Monticello Nuclear Generating Plant
Docket 50-263
License No. DPR-22

Response to Request for Additional Information for a License Amendment Request for Contingent Installation of a Temporary Fuel Storage Rack in the Spent Fuel Pool (TAC No. MD0302)

STRUCTURAL RAI INFORMATION RESPONSE

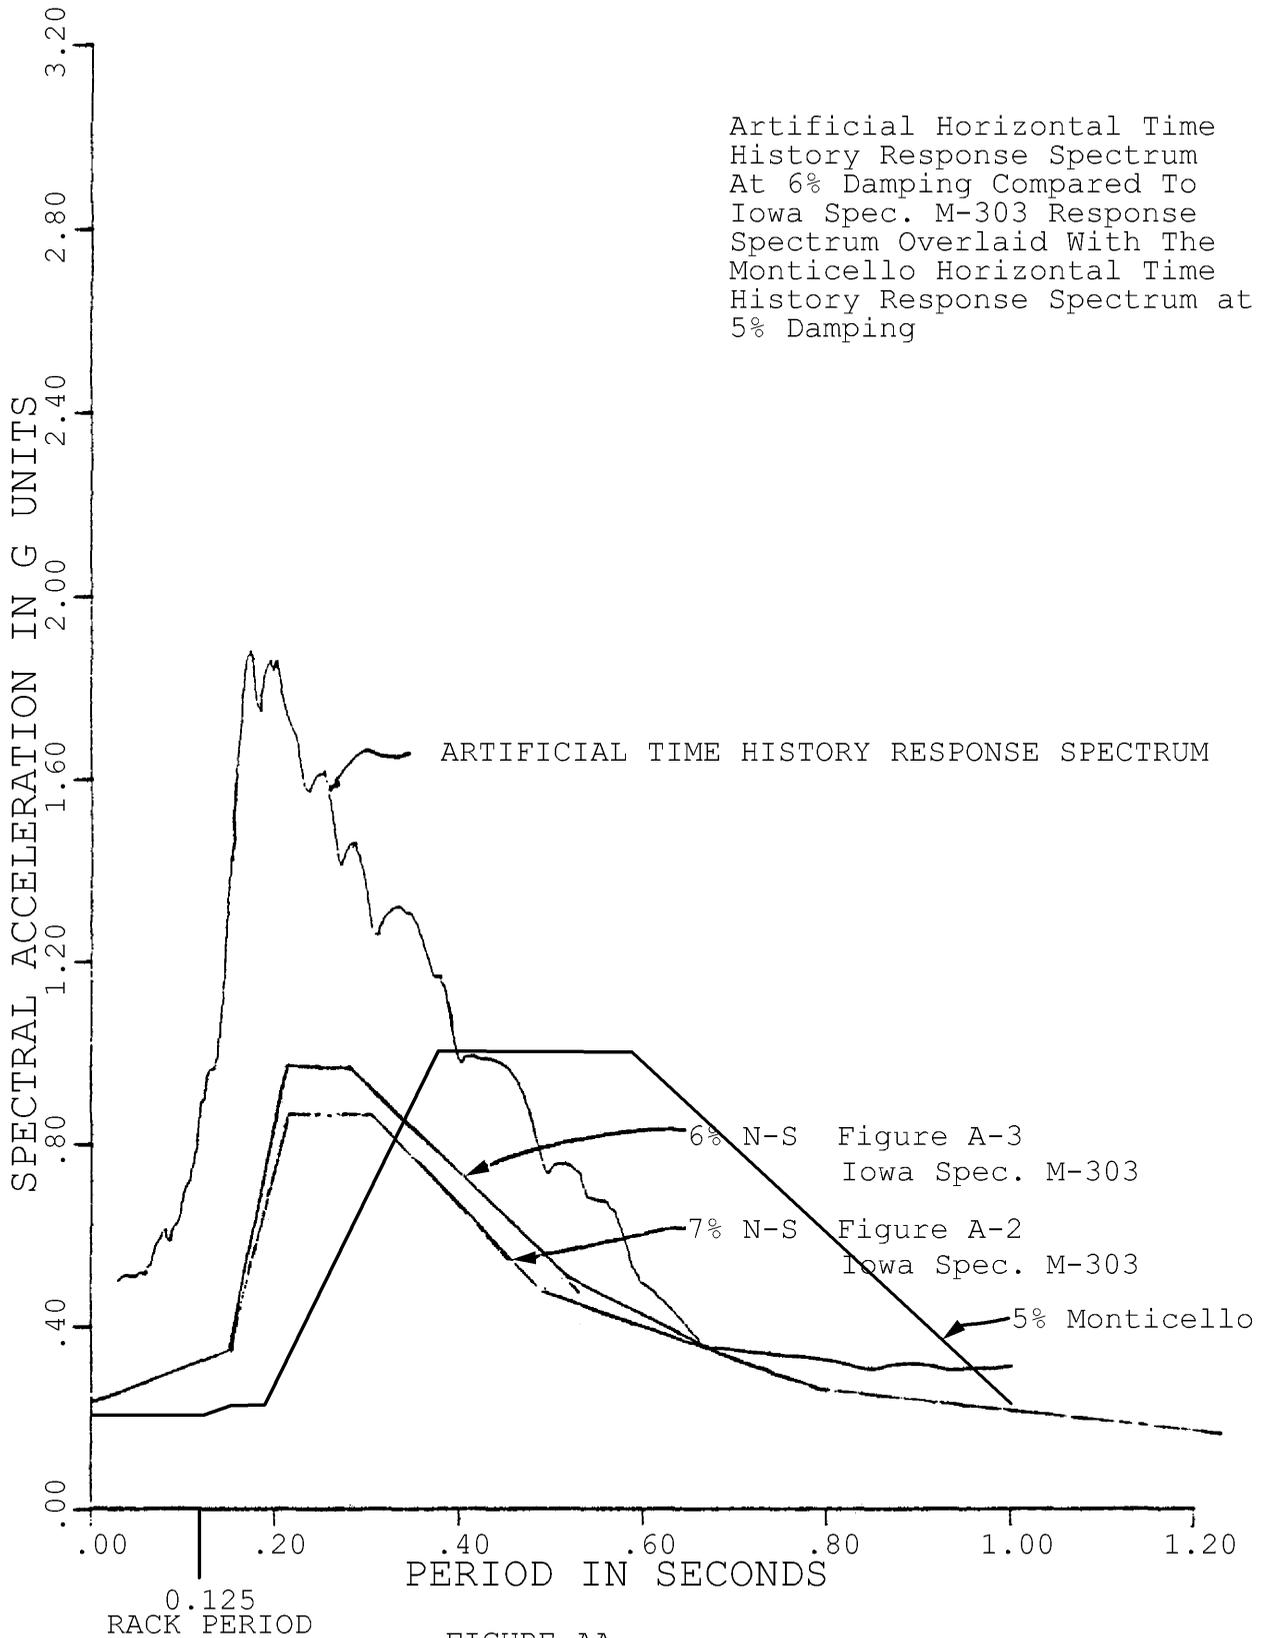
The location of the temporary 8x8 PaR fuel storage rack module in relation to the existing fuel storage rack modules in the SFP is shown on the mark-up of MNGP Drawing No. NX-7865-15-36, entitled High Density Fuel Storage System Installation Arrangement, and is provided in Enclosure 2.

FIGURE AA

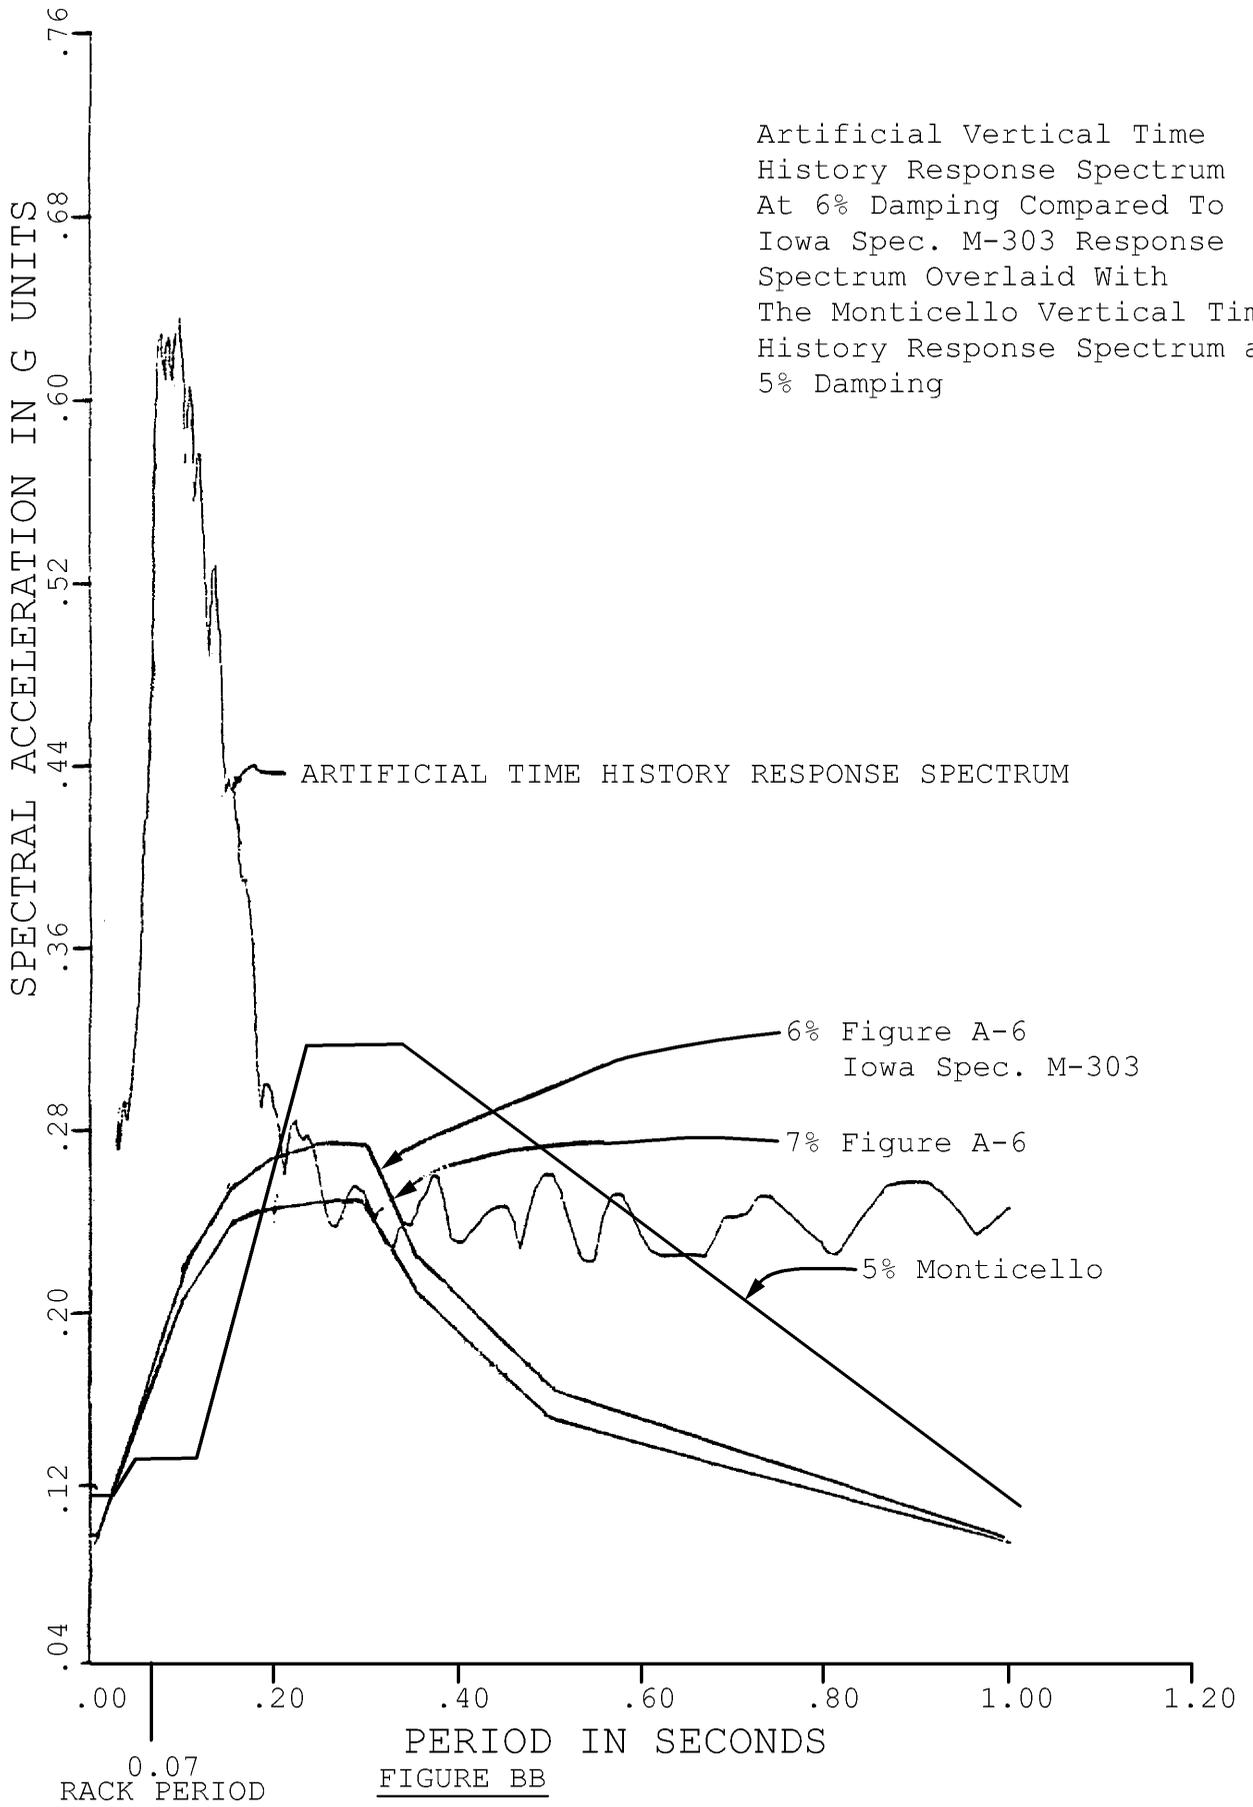
As shown in Figures AA and BB in Enclosure 2, the time history response spectrum used in the PaR analysis bounds the MNGP response spectrum in the frequency range of interest (i.e., the frequency range of the 8x8 fuel storage rack module). The first natural horizontal frequency of the fuel storage rack module analyzed by PaR was 8 hz (0.125 second period)

(see PaR Report, Section 5.3, "Model Description, Formulation and Assumptions for the Seismic Analysis of BWR Spent Fuel Racks," page 5.3-4). As shown on the plot, at this frequency of interest, the MNGP response spectrum is well below the time history response spectrum used in the PaR analysis. The first natural vertical frequency of the fuel storage rack module analyzed by PaR was 14 hz (0.07 second period) (see PaR Report, Section 5.3, page 5.3-4). Also, as shown on the plot, at this frequency of interest, the MNGP response spectrum is well below the time history response spectrum used in the PaR analysis. Accordingly, it is concluded that the seismic evaluations in the PaR Report are bounding for the MNGP. Therefore, the PaR 8x8 fuel storage rack module will withstand the MNGP SSE loads.
